ADDENDUM #3

TO THE CONTRACT DOCUMENTS FOR THE CITY OF PALM BAY

IFB # 39-0-2020/JG, South Regional Water Reclamation Facility Construction

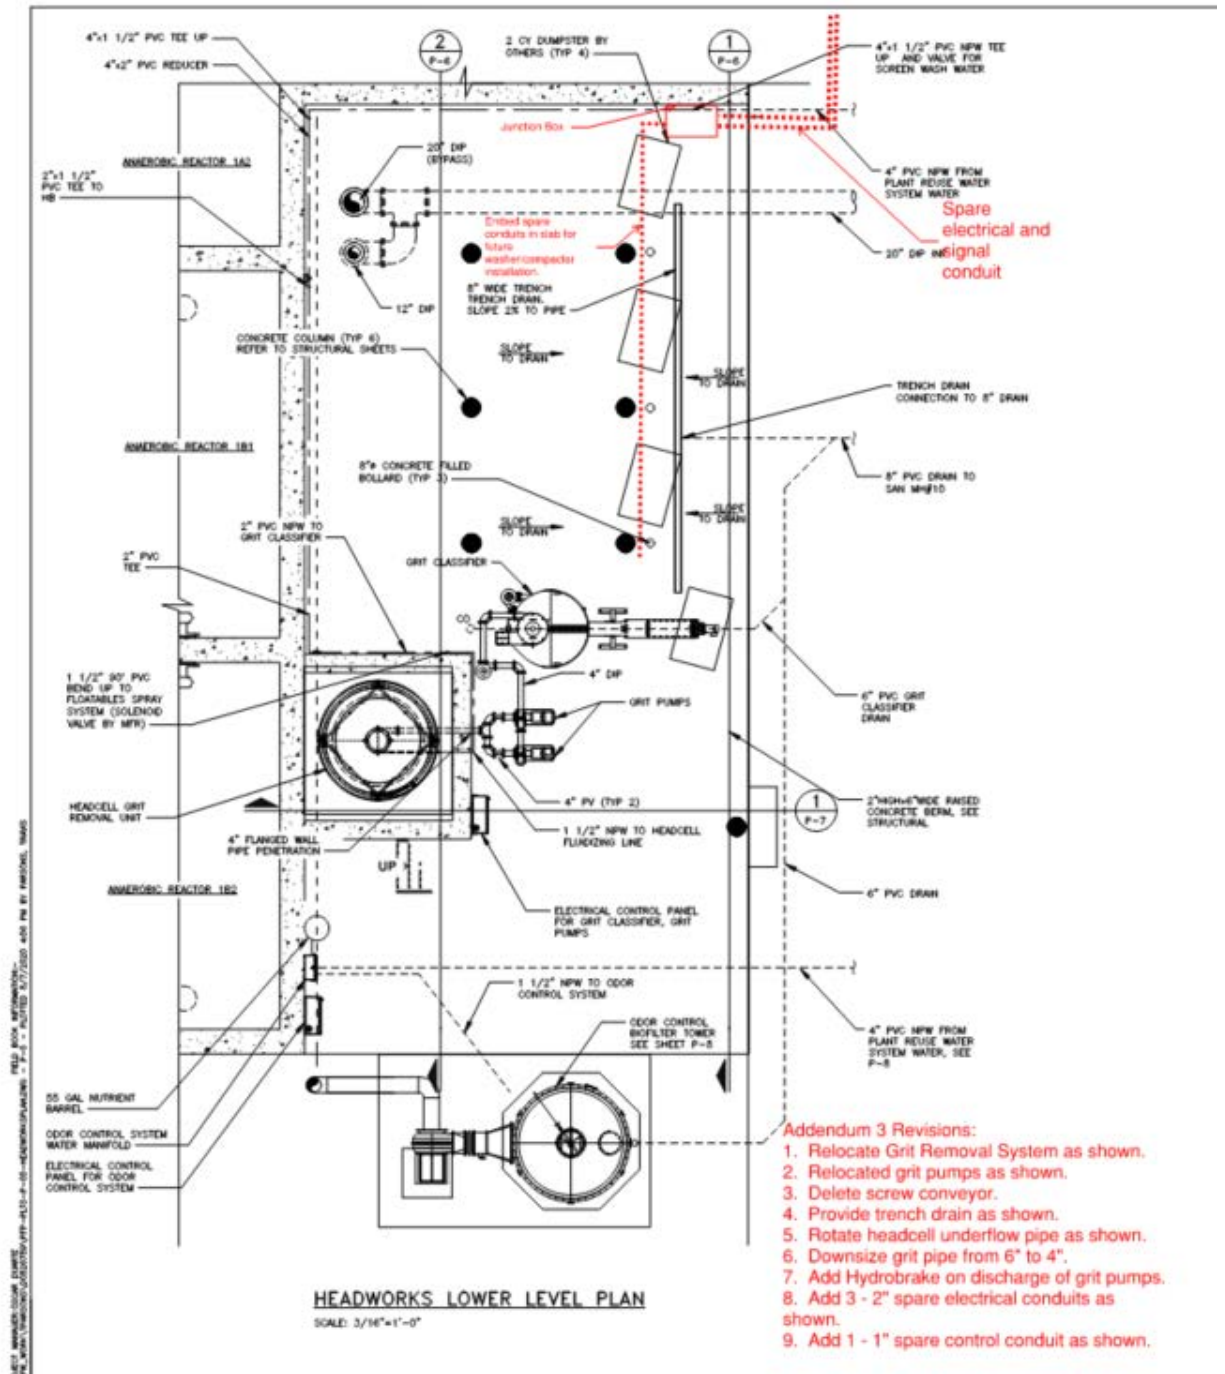
Q46. 1.03.A: This section references an expandable HC unit. The drawings show a full 9’ 8 Tray design and the spec outlines a 9’ 8 Tray design. Is the Headcell expected to be expandable and what quantity of trays will be required initially? The most recent proposals done in 2018 were for non-expandable units.

A46. The full, non-expandable, Headcell unit will be required to meet the future peak flow.

Remove the term “expandable” from Specification Section 11700 – Grit Removal System, Section 1.03.A

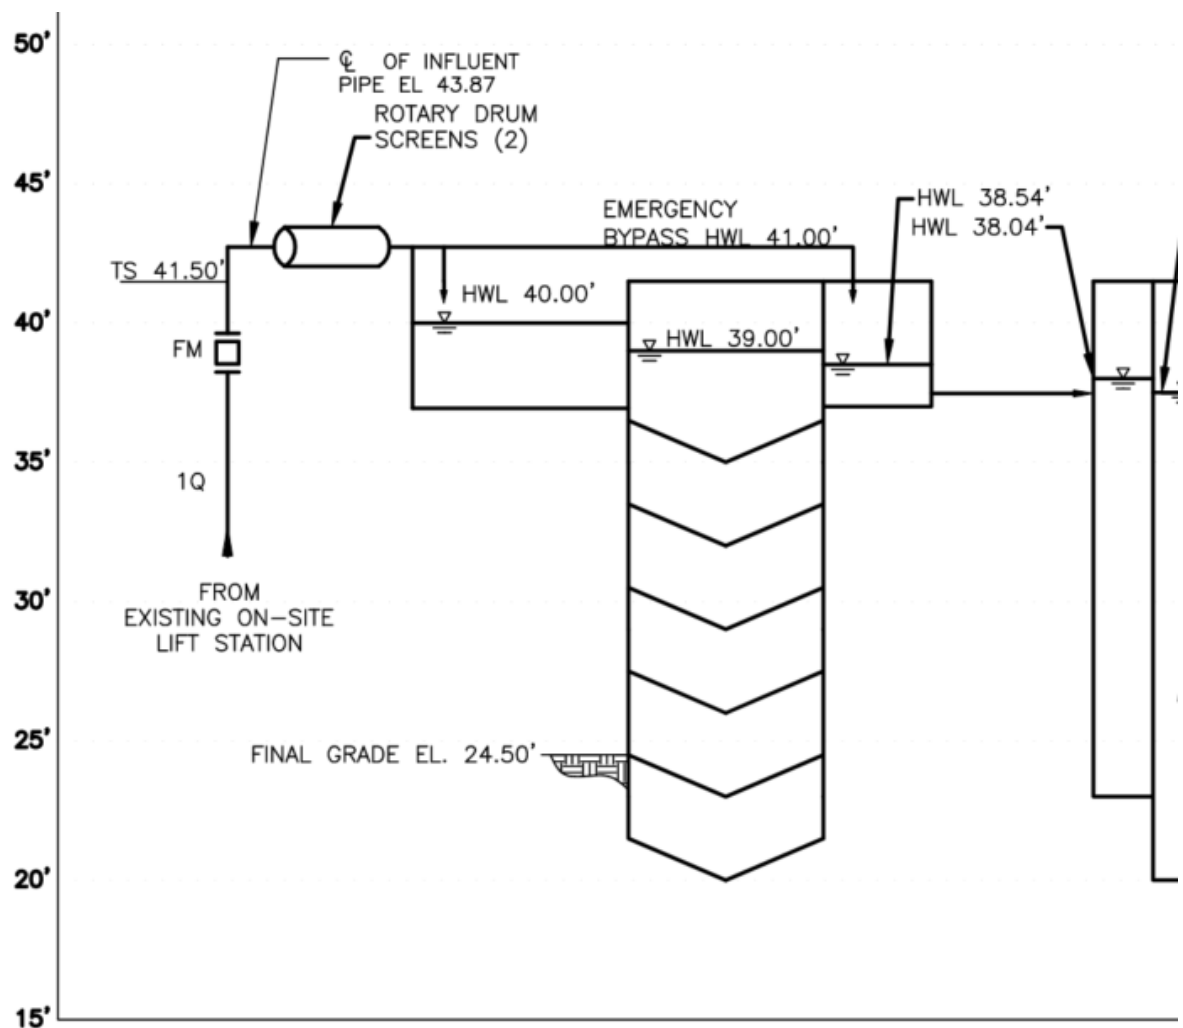
Q47. 2.03.D.3: In 2018 Hydro reviewed 90% documents. As part of that review it was noted that there is not much TDH for a pump to work with in the current layout (i.e. the 15 ft of head listed in the spec isn’t available). We had commented that we could supply a HydroBrake to provide more head for the pump to work against and that valve would need to be located such that the centerline of the valve would be 27” above the overflow channel of the Grit washing/classification unit (GritCup). It is not clear in the drawings if there would be enough elevation space above the GritCup to accommodate this layout. I have attached a very crude sketch of what I am talking about as well as a generic HydroBrake drawing. Please confirm there is the headspace above the GritCup centerline to accommodate.

A47. The grit classifier has been moved to the southeast. The layout has been revised to allow sufficient space. See sketch below.

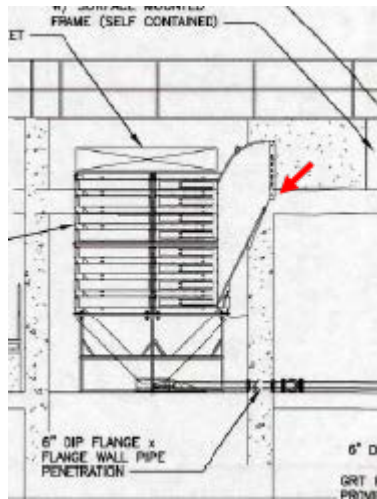
Q50A. 2.03.E: See comments below in the Dwgs section

G-4: There is indication of an emergency bypass HWL of 41.00 and an arrow point down into the Grit Removal tank. Hydro recommends that any bypass is routed around the HeadCell unit not only to allow the unit to be taken off line for maintenance but also to ensure there is no additional flow going into the tank that it is not designed to accommodate.

A50A. The bypass in question on Sheet G-4 is intended to be routed around the headcell unit, see sketch below.

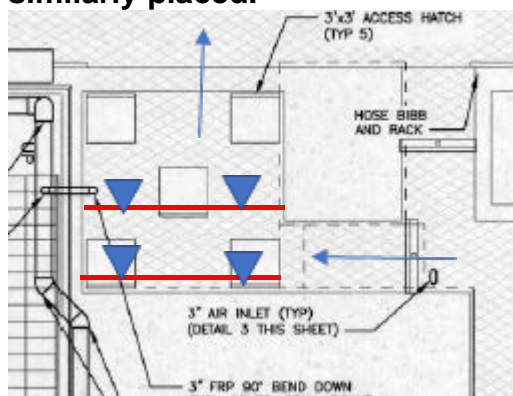
Q50B. P-6: The influent invert of the Grit Removal Unit looks to be falling inside the tank wall. Hydro is not readily finding the elevation of the channel feeding the unit in order to determine what modifications will be required to accommodate that elevation. Please provide the channel elevation.

P-6: The grit slurry line is indicated as being 6" in diameter. Industry guidelines recommend a 4-7ft/s pipe velocity and at a pumped flow rate of 200 gpm it would be recommended to reduce the grit slurry piping to 4" in diameter.

A50B. Response: P-6 Shows the channel elevation at 37.0; the structural sheets show the concrete wall to accommodate the influent channel of the Headcell unit. The wall is correctly shown on Sheet S-14.

On sheets P-5 and P-6 reduce the grit slurry line size from 6" to 4".

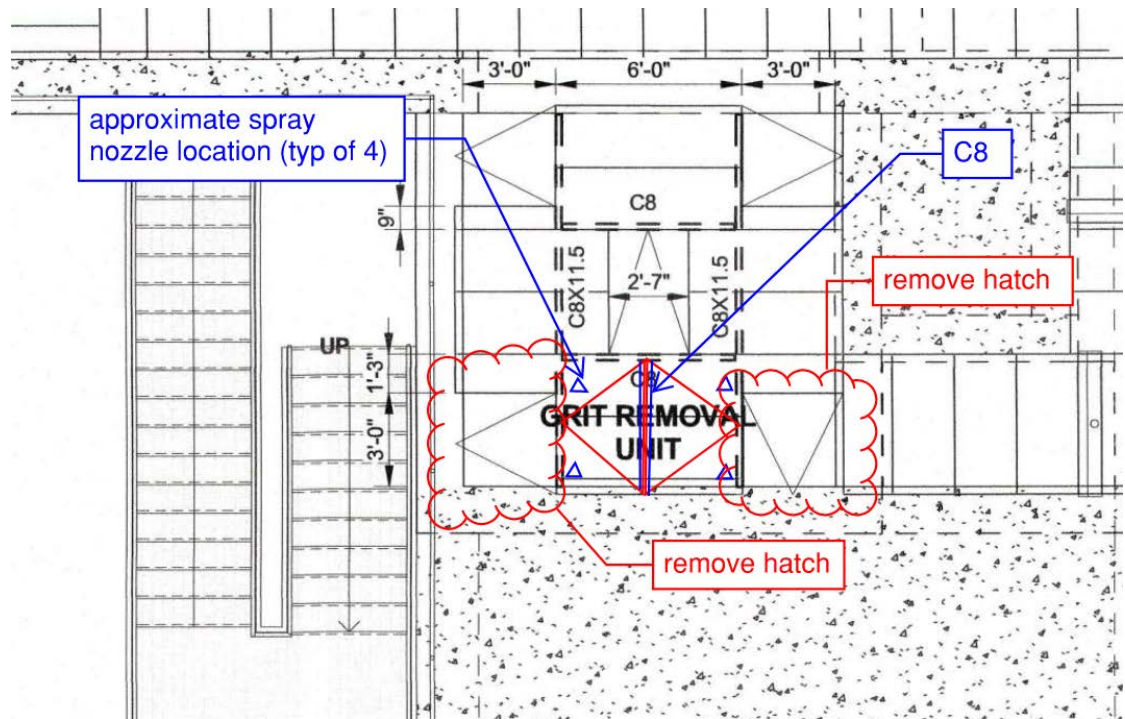
Q50C. P-8: The location for the access hatches will be challenging for access to the spray bar system underneath the cover. Below is a rough sketch of the system. There will be two rows each with two spray nozzles. The bottom right triangle is recommended to be 36" away from the influent tank wall and the second nozzle on that same spray bar is 72" away from the first nozzle. The second spray bar is recommended to be 36" away from the first spray bar with the nozzles similarly placed.

A50C. The entire panel is FRP, opening to be confirmed after the grit removal unit is approved. The basis of design shall be modified per the sketch below by increasing the size of the bottom two hatches and moving them to the center of the opening. This will require an additional C8 member.
